APPLICATION NO.	FILING DATE	FIRST NAMED INVENTOR	ATTORNEY DOCKET NO.	CONFIRMATION NO.
10/785,209	02/24/2004	Ronald P. Hohmann JR.	PHO-236 CIP	8805
48745 SILBER & FRI	7590 10/06/200 DMAN	EXAMINER		
1037 ROUTE 46 EAST			FIGUEROA, ADRIANA	
SUITE 207 CLIFTON, NJ (07013		ART UNIT	PAPER NUMBER
			3633	
			MAIL DATE	DELIVERY MODE
			10/06/2008	PAPER

Application No.	Applicant(s)				
Office Action Comments	10/785,209	HOHMANN, RONALD P.				
Office Action Summary	Examiner	Art Unit				
	Adriana Figueroa	3633				
The MAILING DATE of this communication appears on the cover sheet with the correspondence address Period for Reply						
A SHORTENED STATUTORY PERIOD FOR REPLY IS SET TO EXPIRE 3 MONTH(S) OR THIRTY (30) DAYS, WHICHEVER IS LONGER, FROM THE MAILING DATE OF THIS COMMUNICATION. - Extensions of time may be available under the provisions of 37 CFR 1.136(a). In no event, however, may a reply be timely filed after SIX (6) MONTHS from the mailing date of this communication. - If NO period for reply is specified above, the maximum statutory period will apply and will expire SIX (6) MONTHS from the mailing date of this communication. - Failure to reply within the set or extended period for reply

Hohmann (US 4,598,518)

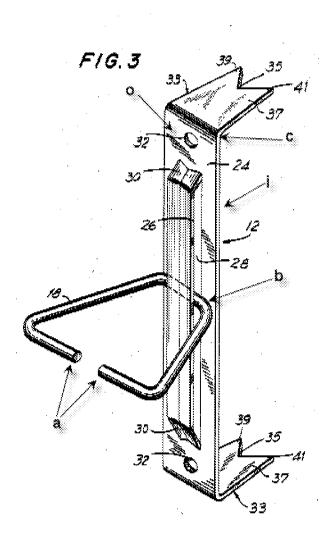
Regarding claim 1, Hohmann discloses a surface-mounted anchoring system for use in the construction of a wall having an inner wythe (19) and an outer wythe (20), said outer wythe formed from a plurality of successive courses (22) with a bed joint between each two adjacent courses, said inner wythe and said outer wythe in a spaced apart relationship the one with the other forming a cavity therebetween, said inner wythe having an exterior layer being insulation (17), (Figures 1, 2), said surface-mounted anchoring system comprising: an anchoring system having a wall anchor (12) constructed from a plate-like body (24) having two major faces being the mounting surface (i) and the outer surface (o), said wall anchor, in turn, comprising; a pair of legs (33), each extending from said mounting surface of said plate-like body from an inboard location thereof with the longitudinal axis of each of said legs being substantially normal to said mounting surface (i), (annotated Figure 3), said legs adapted for insertion at a predetermined insertion point into said exterior layer of said inner wythe,

a covering portion (c) formed at said mounting surface (i) of said plate-like body, said covering portion adapted to preclude penetration of air, moisture and water vapor into said exterior layer, (annotated Figure 3);

an apertured receptor portion (28) adjacent said outer surface (o) of said platelike body (24), (annotated Figure 3), said aperture receptor portion adapted to limit displacement of said outer wythe toward and away from said inner wythe;

a veneer tie (18) threadedly disposed through said apertured receptor portion (28), (annotated Figure 3) of said wall anchor and adapted for embedment in said bed joint of said outer wythe to prevent disengagement from said anchoring system. Hohmann does not disclose the legs having a channel along said axis adapted for sheathing mounting hardware, or at least one strengthening rib impressed in said platelike body parallel to said apertured receptor portion. However, Stephens teaches an anchor having at least one strengthening rib (11) impressed in a plate-like body (5) parallel to an apertured receptor portion (6), (Figure 1). Therefore, it would have been obvious to a person having ordinary skill in the arts at the time of the applicant's invention to modify the anchor of Hohmann to include strengthening ribs parallel to the apertured receptor body and in each of the legs as taught by Stephens, as it is well known in the art to add ribs to sheet metal members, as they provide reinforcement by adding strength and rigidity to the sheet metal.

Regarding claim 7, Hohmann modified by Stephens discloses the claimed invention; Hohmann further teaches an attachment portion (a) for threading through said apertured receptors (28); an insertion portion (b) contiguous with and opposite said attachment portion, said insertion portion being swaged for interconnection with said reinforcement wire, (annotated Figure 3);

In response to applicant's argument that Hohmann '518 does not teach "a covering portion". Examiner asserts that the portion (c) indicated in the annotated Figure 3 would create a cover portion between the leg and the inner surface of the body.
